FORD E40D "UPDATE HANDBOOK"

INTRODUCTION FORD E4OD "UPDATE HANDBOOK"

**FORD E40D
VALVE BODY, SPACER PLATE, SPACER PLATE GASKETS,
CHECKBALL LOCATIONS, AND CASE CHANGES,
FOR THE 1996 MODEL YEAR**

Figure 29

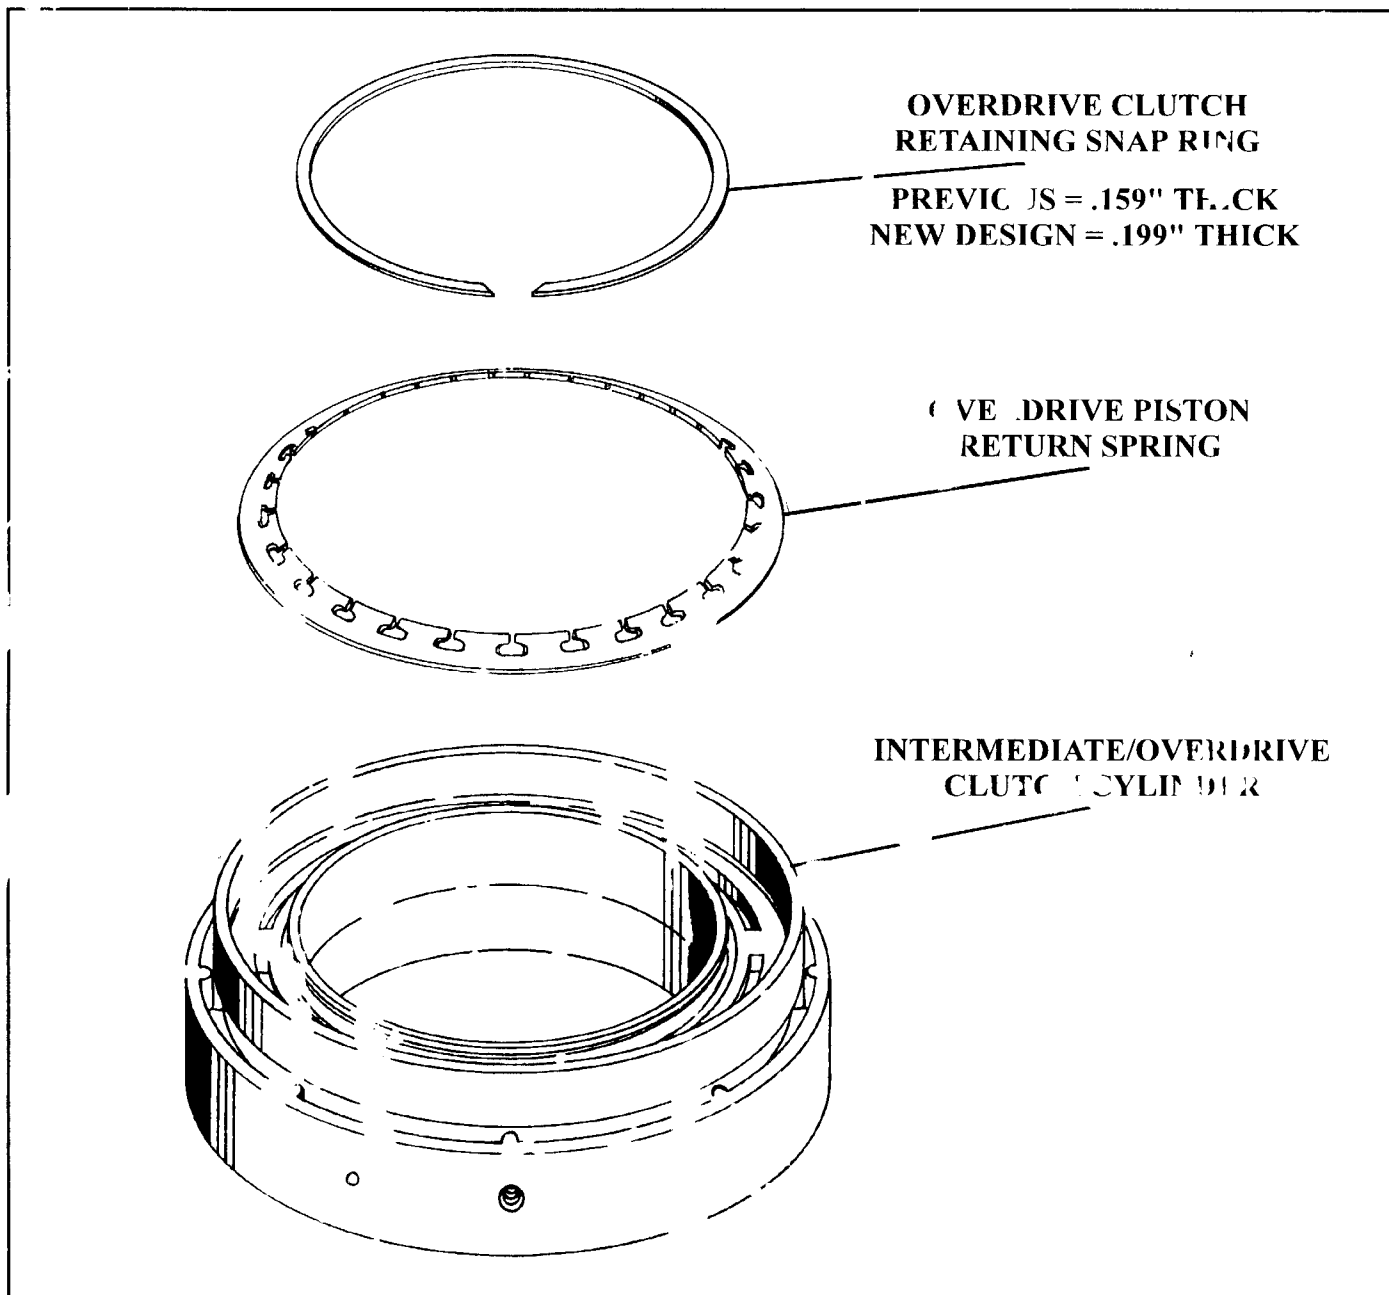
COMPLAINT: Harsh 3-4 shift, and/or, upon transmission disassembly the Overdrive Clutch retaining snap ring is dislodged from the groove (See Figure 29).

CAUSE: Insufficient tension on the Overdrive Clutch Snap Ring.

CORRECTION: Install a new design (Thicker) snap ring that has more tension than the previous design. The new design snap ring is .199" thick and the previous design is .159" thick, as shown in Figure 29.

Figure 30

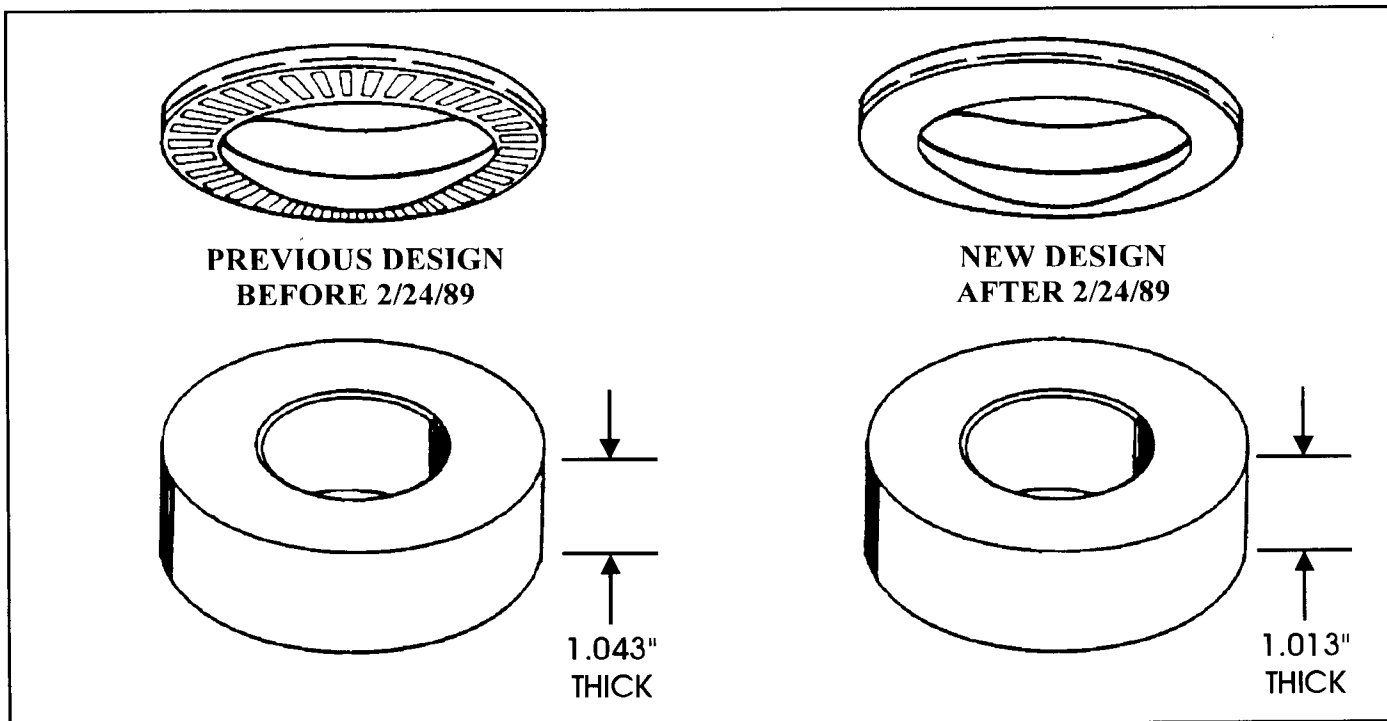
- (1) **LOW ROLLER CLUTCH INNER RACE** - As of 2/24/89, the Low Roller Clutch Inner Race height has been reduced by .030" to accommodate a revised hub to race thrust bearing. The previous inner race height was 1.043" and the new design is 1.013", as shown in Figure 30.
- (2) **HUB TO RACE THRUST BEARING** - The previous thrust bearing was a **2 Piece** (open face) design, and the new design is a **3 Piece** (closed) design bearing. The thickness of the previous 2 piece thrust bearing is .110" thick, and the new design 3 piece bearing is .140" thick, so that it is compatible with the new thinner inner race (See Figure 30).

Figure 31

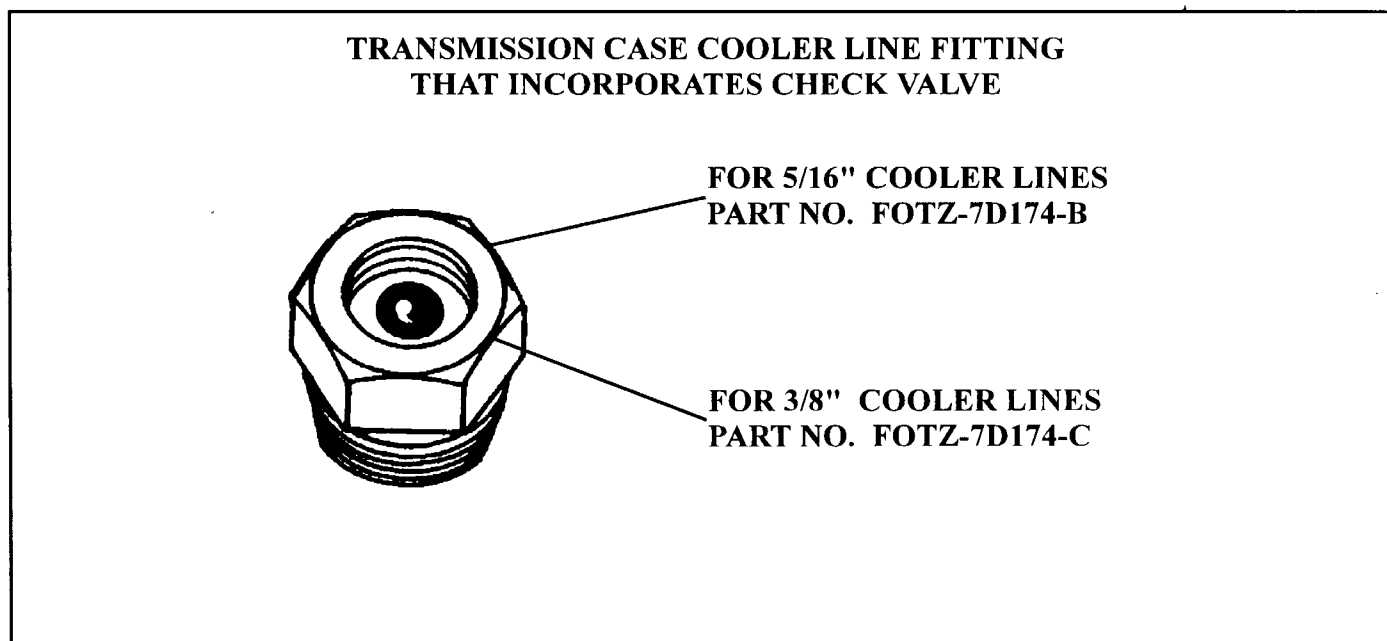
CHANGE: Beginning in mid-year of the 1990 model year, Ford Motor Company incorporated a check valve into the rear cooler line fitting as shown in Figure 31.

- (1) **REAR COOLER FITTING** - Now incorporates a check valve inside the cooler line fitting, as shown in Figure 31. There are two different size fittings, one for 3/8" cooler lines and one for 5/16" cooler lines.

Figure 33

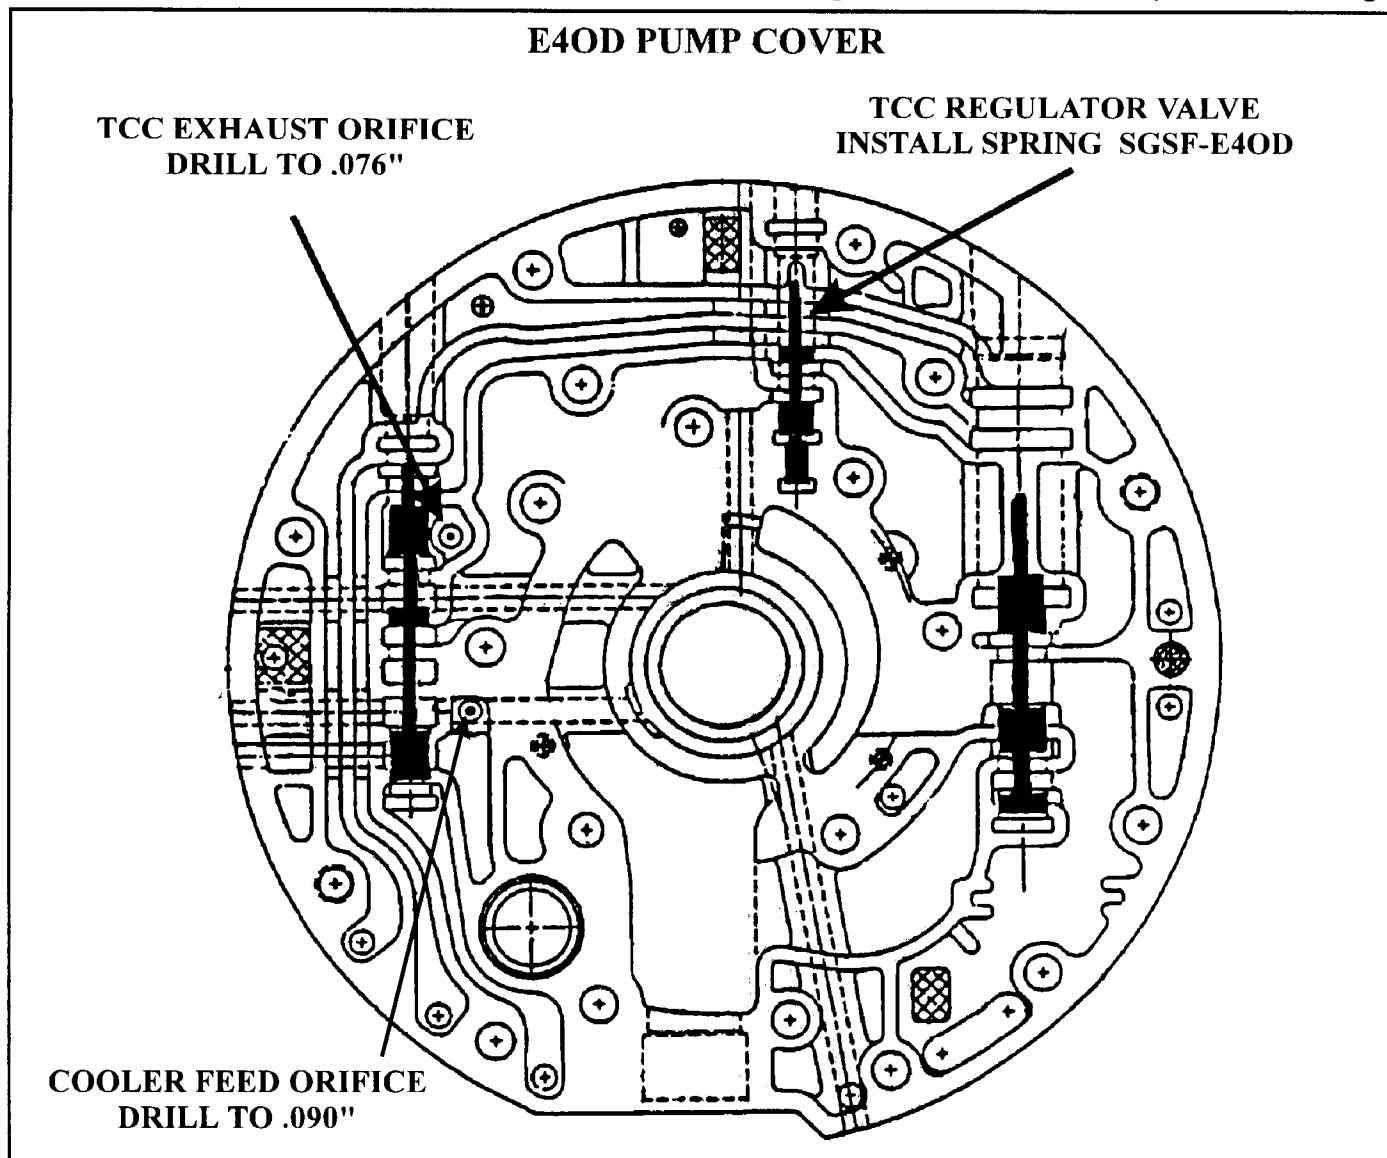
CORRECTION: Replace the converter clutch regulator valve spring, located in the pump cover with a "SGSF E4OD" shudder fix spring as shown in Figure 33. Also drill the converter clutch exhaust orifice out to .076", as shown in Figure 33.

It is also recommended to drill out the cooler orifice to .090" for increased lube flow, as shown in Figure 33.

NOTE: Ford Motor Company replaced this spring with a heavier spring in 1992 and later models, so ensure the spring you are installing is *heavier* than the one you are removing.

Figure 34

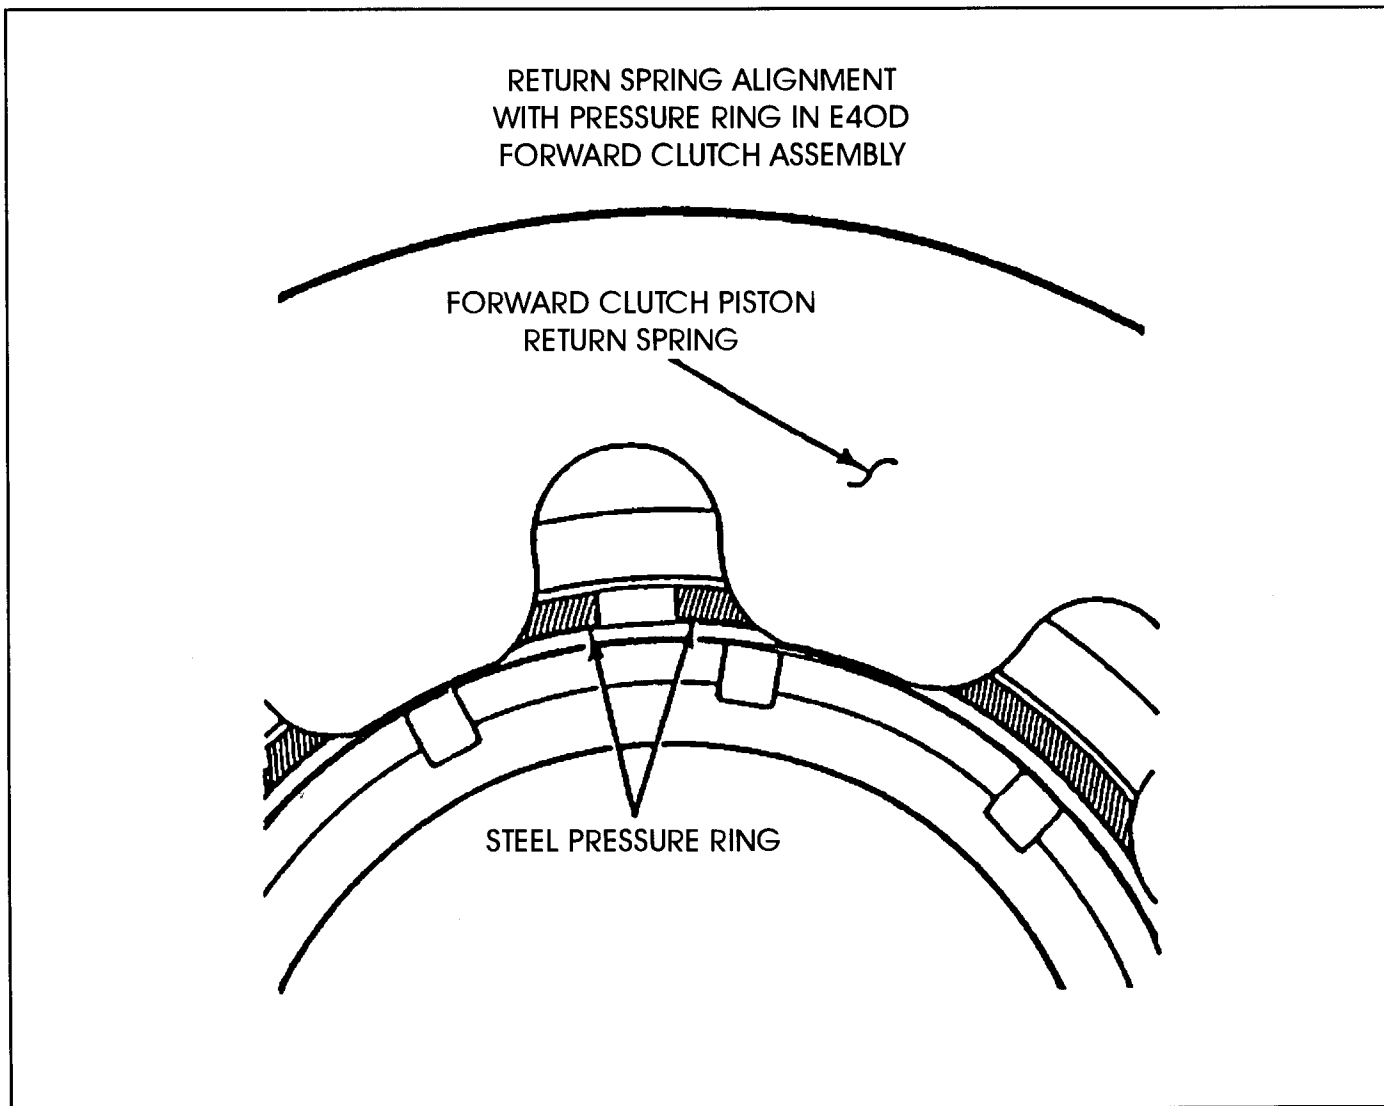
CAUSE: The cause may be, improper orientation of steel ring on top of the forward clutch piston, and the forward clutch piston return spring.

CORRECTION: Position the forward clutch piston return spring so that both ends of the steel ring are visible within the space between the two adjacent fingers of the return spring as shown in Figure 34.

Figure 37

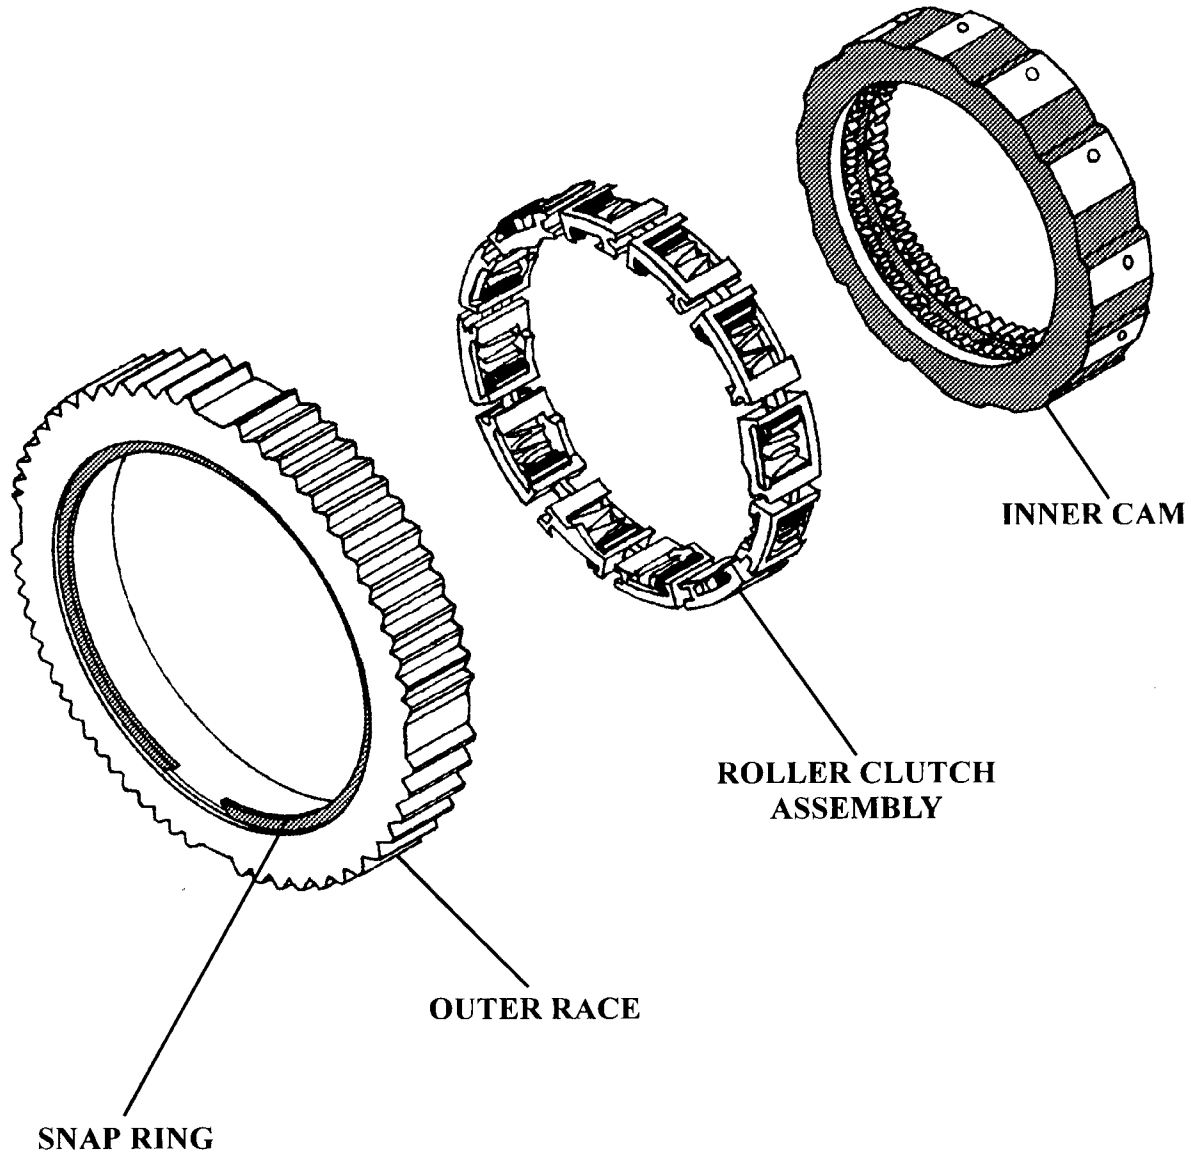
The previous design Overdrive Sprag (E9TZ-7A089-A) *is no longer available*. The previous part number will now supercede to one of the part numbers listed below under "Service Information", as there is one number for F-Super Duty and Motorhomes and another number for all others. The new design "Overdrive Roller Clutch Service Kit" will retro-fit back on *all* previous models (See Figure 37).

Figure 44
AUTOMATIC TRANSMISSION SERVICE GROUP

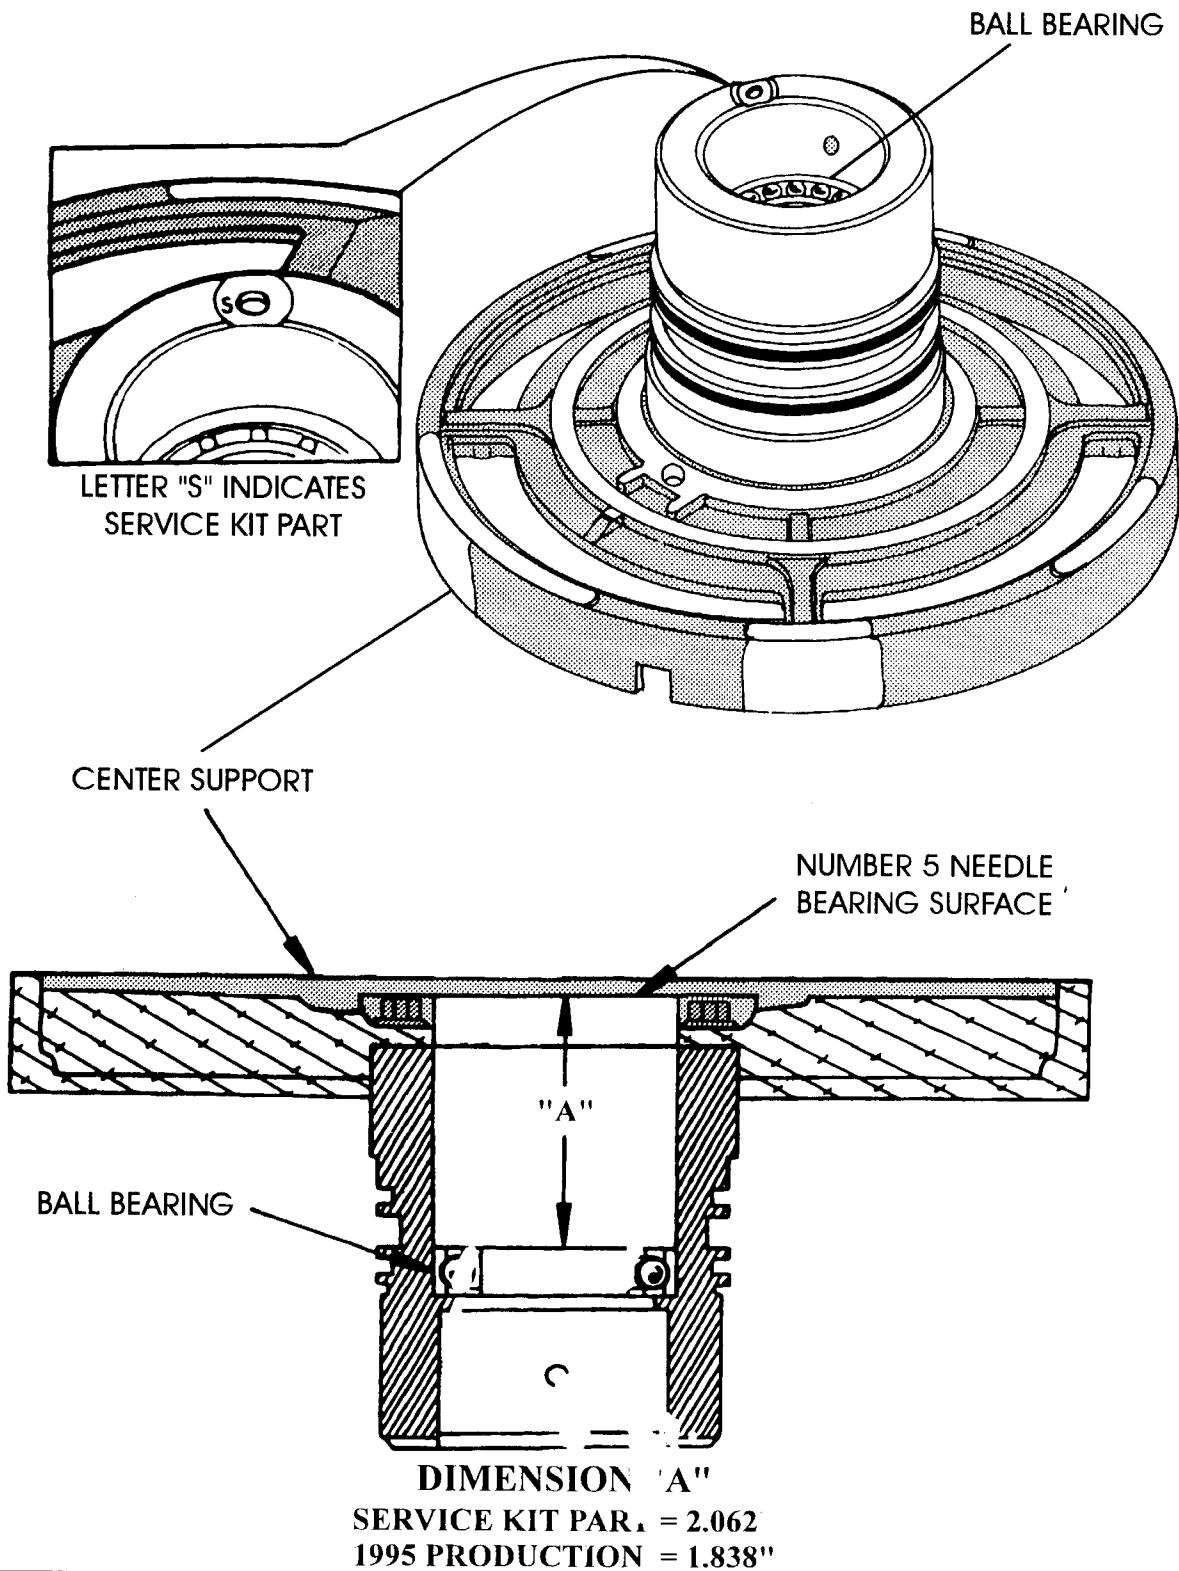
- (1) CENTER SUPPORT - Different machining dimensions on the inside bore, to accommodate an added ball bearing that will now support the overdrive center shaft. The new design ball bearing support can be identified as a "Service Part", by the letter "S" stamped on hub, in the location shown in Figure 44. The Service Kit Ball Bearing Center Support has different dimensions than the 1995 production ball bearing center support. Refer to Dimension "A" on the cutaway drawing shown in Figure 44.
